**ADDENDUM**

**ADDENDUM NO. [1]                      Date: May 11, 2010**

**RE:            LHA INFRASTRUCTURE UPGRADES (BID PACKAGE B)  
HOUSING AUTHORITY OF THE CITY OF LA CROSSE  
LA CROSSE, WISCONSIN  
HSR PROJECT NO. L09042 BP-B**

# 10 LOUVER INSTALLATION DETAIL

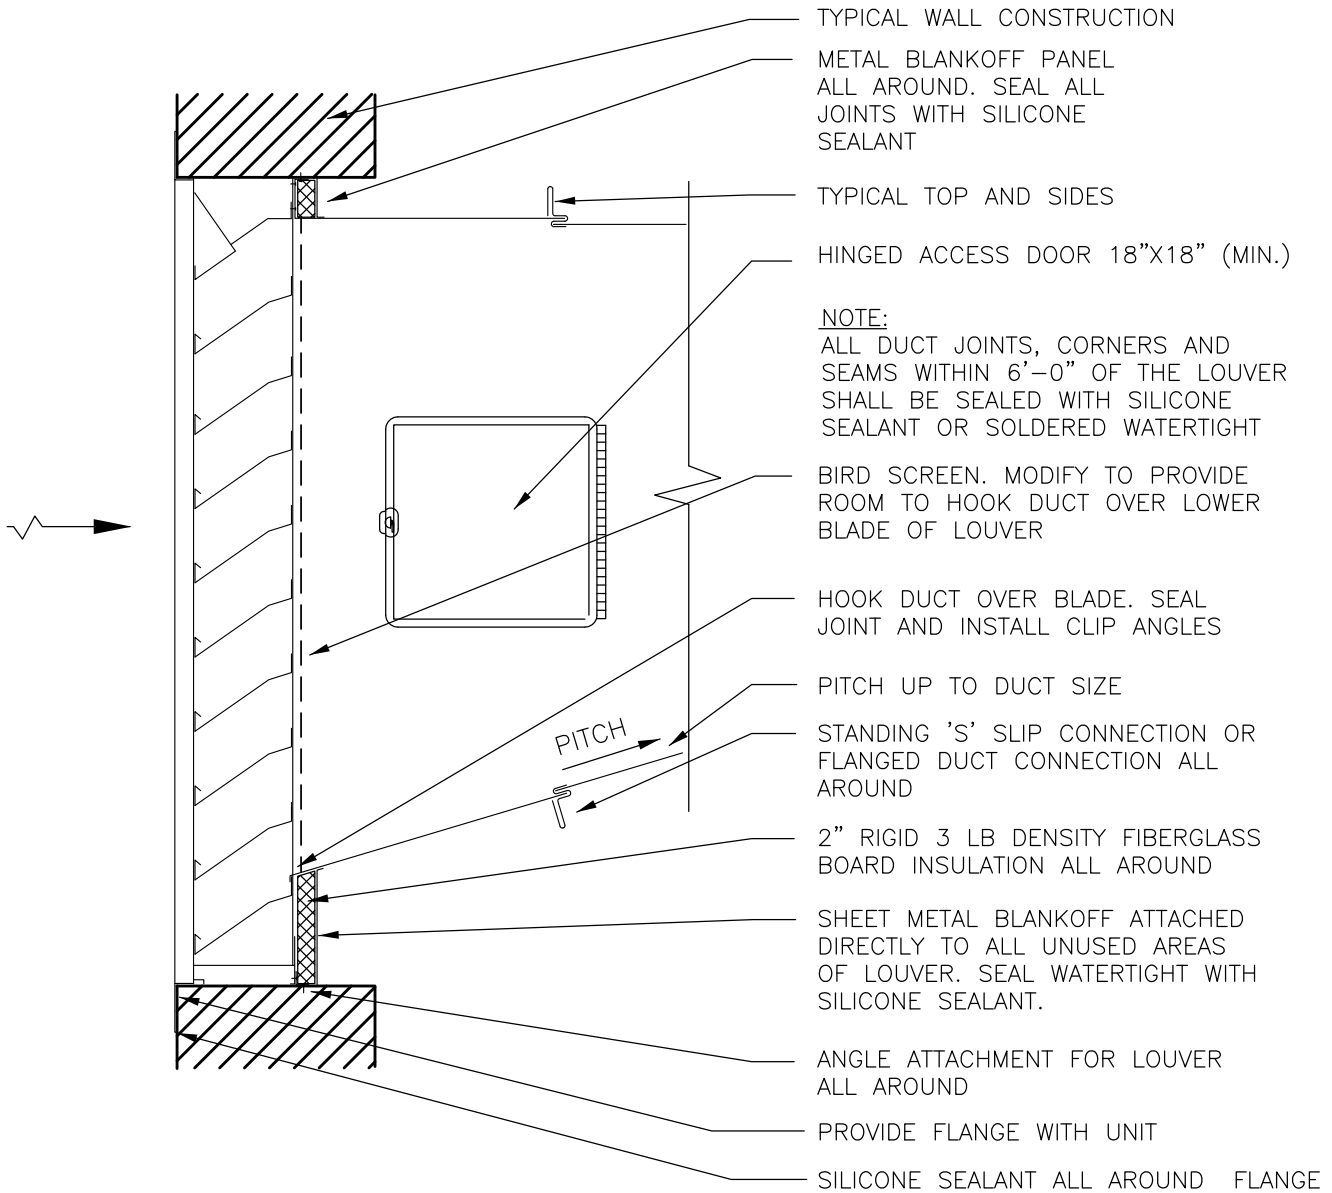
**NOTE:**  
LOUVER SHALL BE OF THE SIZE, TYPE,  
DEPTH AND CONSTRUCTION AS LISTED  
IN ADDENDUM #1.

4. Drawing 1M3, New gas piping connection shall be 2" in lieu of 3".
5. Detail 9M5, existing ductwork and filter shall be removed to inside areaway. Provide a new grating to cover the areaway opening. Provide a new louver L-1 in the wall opening for the outdoor air in the areaway. New louver shall be an American Warming LE-31 or equal. Size to be 96x48, 18.9 square feet of free area.

6. See Attached drawing 2M4R1, Section at AH-1.
7. See Attached drawing 10M5R1 for Louver Installation Detail.
8. Clarification: Refer to Drawing E2 for the location of the variable frequency drives (VFD's) for Stokke Tower.
